Report: PRELIMINARY TAB REPORT

Function: Test, Adjust, & Balance

04-14-25 ULTA 1697 SELMA, NC

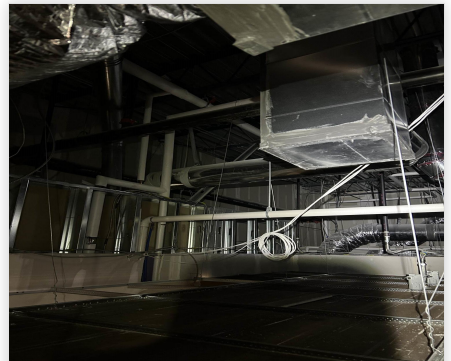
Issue Name : EF-1 curbed wrong
Description : EF-1 fan curbed to the wrong ductwork. The fan is installed to the water heater exhaust. Also, the motor is at max amps, going to a 10" round duct. Currently getting 522 cfm. EF-1 is design for 1750 cfm. The Greenheck GB-130 website states that max flow is 1249 cfm.
Created By : National TAB **Assigned To :** National TAB - Dan Hertenstein
Status : Open
Priority : Urgent **Asset Tag :** EF1
Originated Date : 01/08/2025 - Jearod Ferrette - National TAB

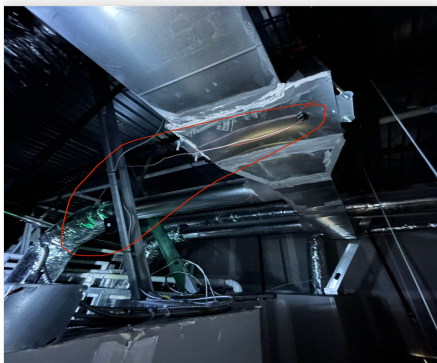
Issue Name : EF-2 Dampers not installed
Description : EF-2 dampers are not installed. However the airflows are proportional so they likely will not be required.
Created By : National TAB **Assigned To :** National TAB - Dan Hertenstein
Status : Open
Priority : Low **Asset Tag :** EF2
Originated Date : 10/17/2024 - Will Turnbough - National TAB

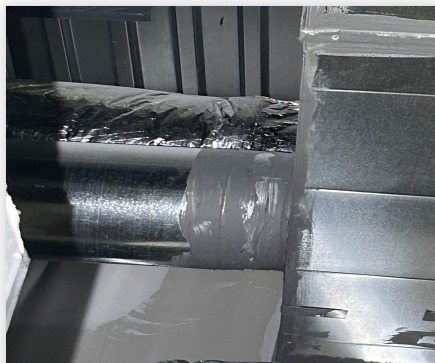
Issue Name : EF-2 Restroom fan unable to access
Description : EF-2 speed controller is located above hard ceiling and is inaccessible. Unable to reach from other side with ladder due to piping obstructing access. The unit is running at 117% of design.
Created By : National TAB **Assigned To :** National TAB - Dan Hertenstein
Status : Open
Priority : High **Asset Tag :**
Originated Date : 10/14/2024 - Jearod Ferrette - National TAB

Asset: EF1

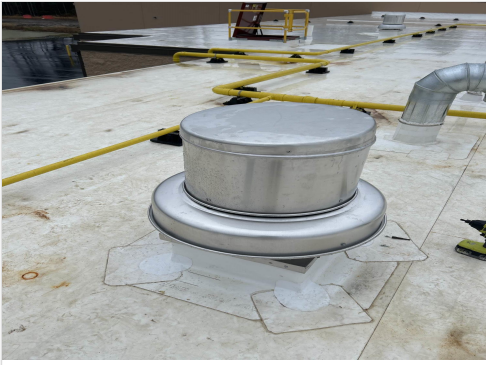
Notes:
-0.935 READ AT FAN
-0.040 BEFORE THE FINAL DIFFUSER
LOW FLOW SEE ISSUE
WRONG MOTOR SEE ISSUE
